Opendoor INSPECTION FINDINGS AND FIXES

7825 W Freedom Eagle Dr, Tucson, AZ

Chris Mackenzie September 23, 2022

11.1.1 Foundation & Floor Condition

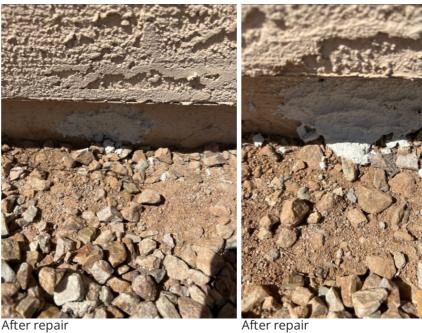
There is concrete spalling and/or deterioration of the stemwall observed. Recommend having the area sealed to prevent further wear. The area should also be monitored for ponding water and addressed as needed.

Several small spots of foundation spalling were fixed with appropriate patching compound to limit future moisture infiltration. This type of spalling is common and should be monitored by the owner for possible future patching and repair.
